AMENDMENTS TO THE DRAWINGS:

REMARKS

Fig. 1

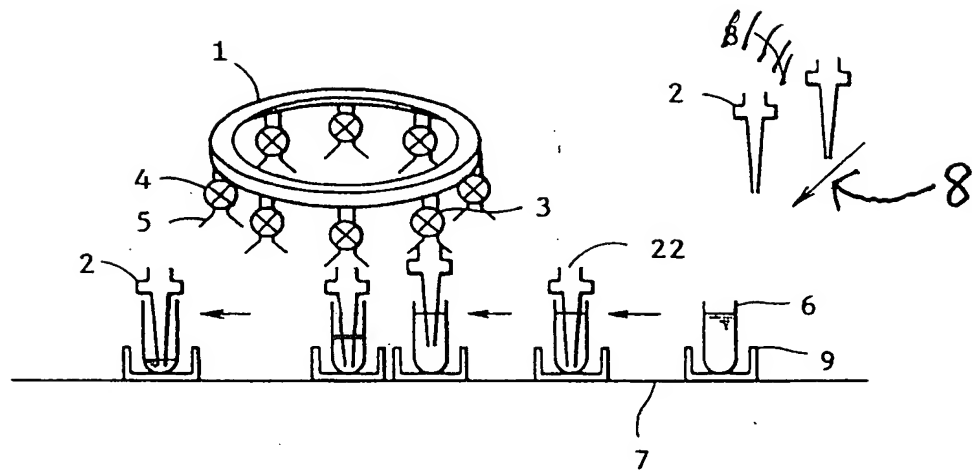
The attached sheet of drawings includes changes to FIG. 1. This sheet replaces the original sheet including Figure 1.

By virtue of the foregoing amendment, claim 15 has been amended to delete the objected to phrase. Also, Figure 1 has been corrected to more clearly indicate that the number 8 refers to a blood filter unit as described at page 16, line 3 of the original specification.

Reconsideration and withdrawal of the objection to the drawings and the rejection of the claims under 35 U.S.C. §112 are respectfully requested. As a result of the foregoing amendment, Figure 1 has been amended to make it clear that the number 8 refers to the blood filter unit theater which is described at page 16 of the original specification as filed. There can be no question but that one skilled in the art reviewing Figure 1 and the description at page 16 would understand that this is a device for feeding the blood filter units in the direction of the arrow shown in the drawing. Accordingly, the objection to the drawing is no longer warranted and should be withdrawn.
